**Westinghouse/EPRI/NRC
Workshop on Reactivity Initiated Accident**

**EPRI & NRC Offices
September 22 & 25, 2008**

Agenda

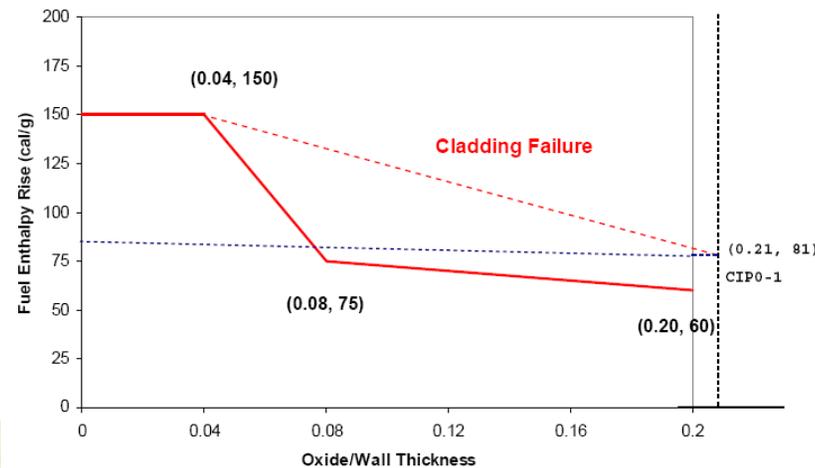
- The step change basis in the existing Figure B-1 is based on NSRR cold capsule test that are non-representative of PCMI, at temperature cladding will maintain sufficient ductility as demonstrated by the CIP0-1 CABRI test
- Thus the proposed failure limit in SRP 4.2, Rev 3, Appendix B, Figure B-1 is excessively conservative

CIP0-1:
~ 110 μ corrosion
98 cal/gm deposited or 81 cal/gm enthalpy rise
An oxide/wall ratio of 0.21
No failure!
